Access Compliance Report

Public Rights-of-Way

Intersection ID: 10025869	Main Street: ELEVATION_POINT_DR	Cross Street: N/A	Location: NE
ADA ID: 3BF7AE417729	Ramp Type: Perp	Initial Pass/Fail: Fail	Overall Compliance: No
		Severity Score: 12.5

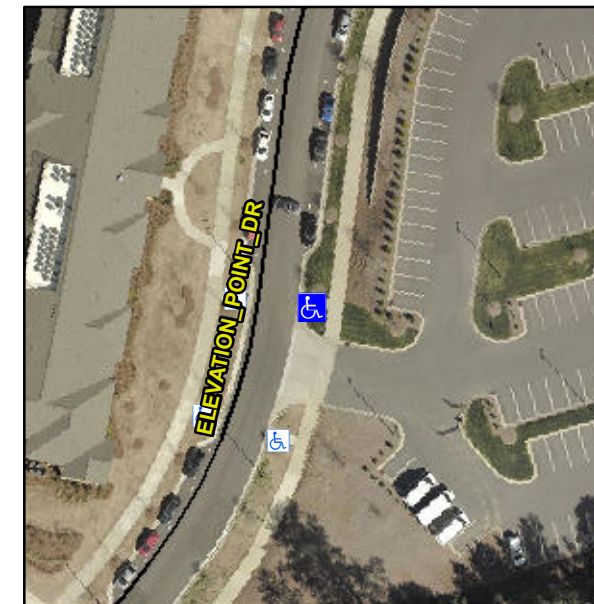
Not Found, R304.2.2

Compliance	Description	Data	Compliance	Description	Data
N/A	Ramp Length (in)	105.0	No	Ramp Slope (%)	8.6
Yes	Ramp Width (in)	59.5	Yes	Ramp XSlope (%)	0.8
N/A	Flare Type LT	N/A	N/A	Flare Type RT	N/A
N/A	Flare Slope LT (%)	N/A	N/A	Flare Slope RT (%)	N/A
N/A	Flare Traversable LT?	N/A	N/A	Flare Traversable RT?	N/A
N/A	Landing Length (in)	N/A	N/A	DWS Provided?	N/A
N/A	Landing Width (in)	N/A	N/A	DWS Contrast?	N/A
N/A	Landing Slope (%)	N/A	N/A	DWS Length (in)	N/A
N/A	Landing X Slope (%)	N/A	N/A	DWS Full Width?	N/A
N/A	Landing Curb? (Y/N)	N/A	N/A	DWS Offset (in)	N/A
N/A	Shared Landing?	N/A			
N/A	Gutter Ponding?	N/A	N/A	Gutter Slope (%)	N/A
N/A	Gutter Lip Ht (in)	N/A	N/A	Gutter X Slope (%)	N/A
N/A	Painted X Walk1?	No	N/A	Painted X Walk2?	N/A
	X Walk 1 Direction	To W		X Walk 2 Direction	N/A
N/A	X Walk 1 Width (in)	N/A	N/A	X Walk 2 Width (in)	N/A
	X Walk 1 Slope (%)	2.4		X Walk 2 Slope (%)	N/A
	X Walk 1 X Slope (%)	3.1		X Walk 2 X Slope (%)	N/A

Remove & Replace Entire Ramp.
